Development Application **ACCESS REPORT**

Reference Number: 24124

31-37 Phillip Street, Raymond Terrace,
NSW

Level 1 plan – LAHC A

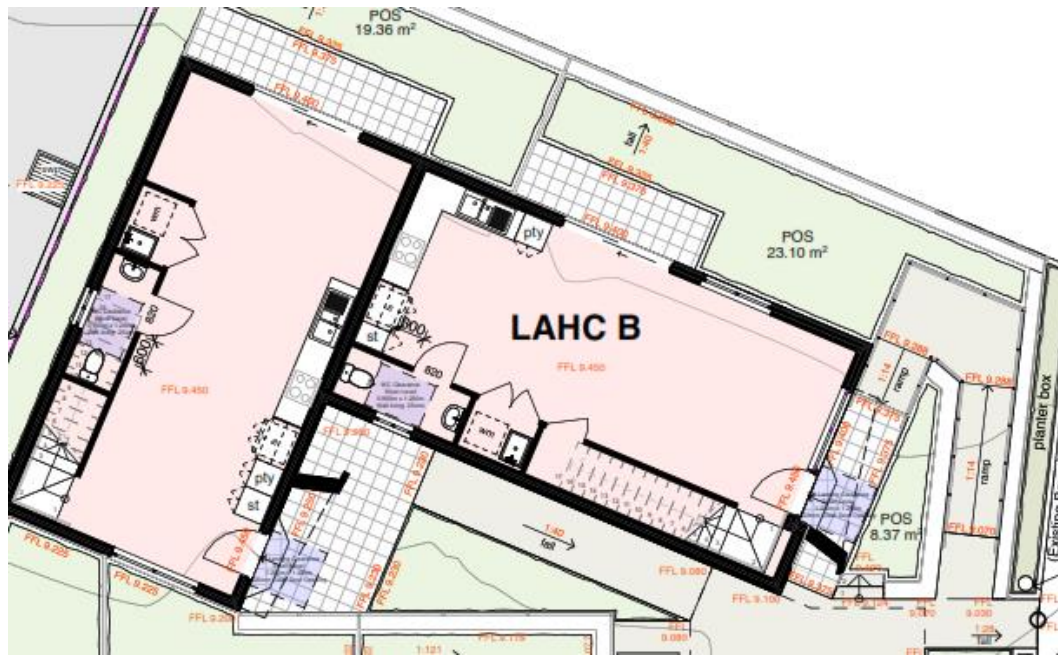
Note: Step free access has been achieved via 1:14 grade ramps at the site boundary. While no requirements apply for common use ramps and common use external steps (as BCA and APS do not apply to Class 1a dwellings), it is recommended that the common use 1:14 grade ramps are designed to be compliant with AS1428.1 features such as handrails and TGSIs.

Level 1 plan – LAHC B

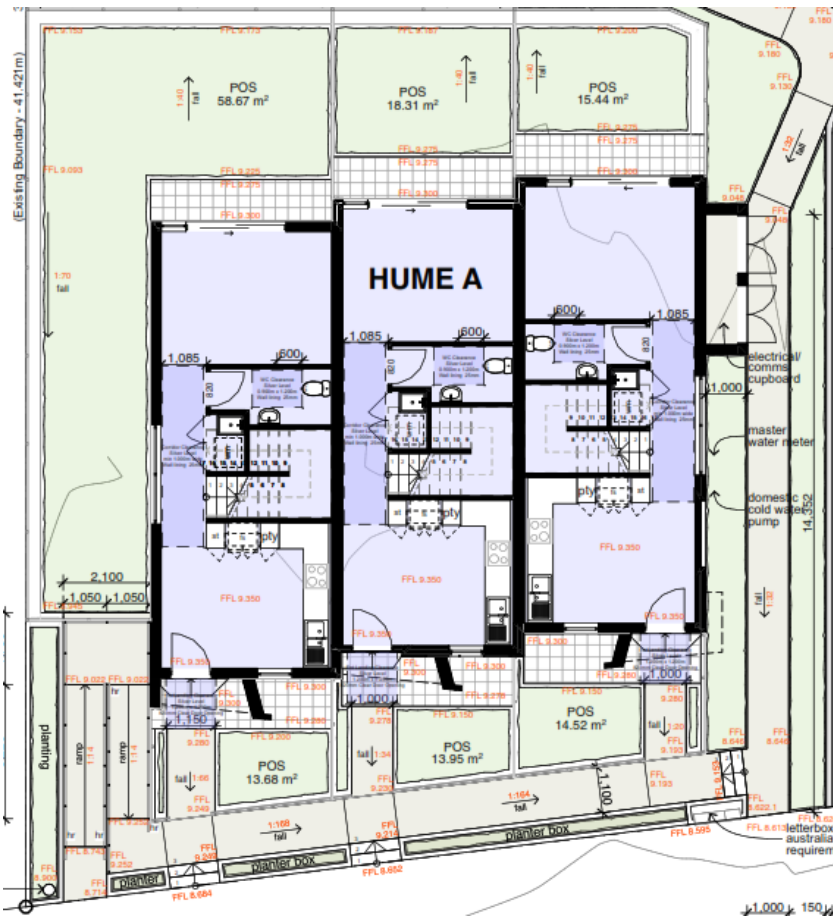
Note: Step free access has been achieved via 1:14 grade ramps at the site boundary. While no requirements apply for common use ramps and common use external steps (as BCA and APS do not apply to Class 1a dwellings), it is recommended that the common use 1:14 grade ramps are designed to be compliant with AS1428.1 features such as handrails and TGSIs.

Level 1 plan – HUME A

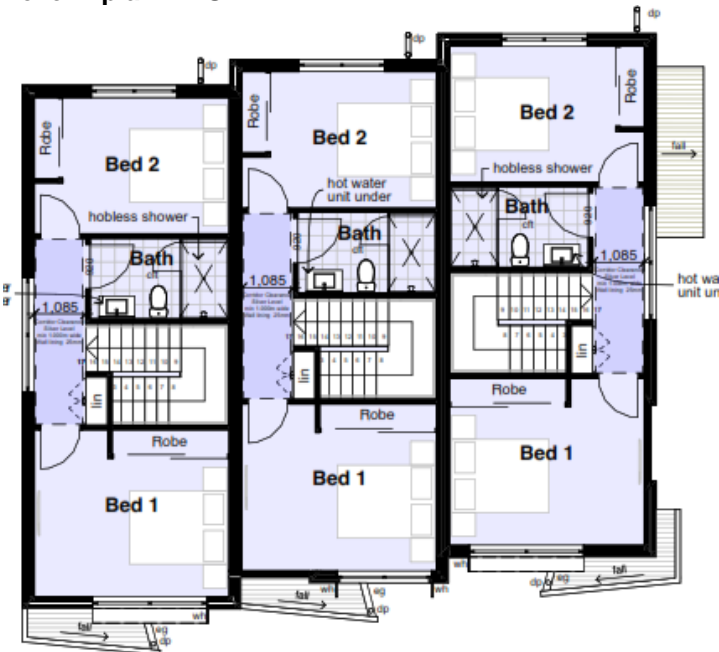
Note: Step free access has been achieved via 1:14 grade ramps at the site boundary. While no requirements apply for common use ramps and common use external steps (as BCA and APS do not apply to Class 1a dwellings), it is recommended that the common use 1:14 grade ramps are designed to be compliant with AS1428.1 features such as handrails and TGSIs.
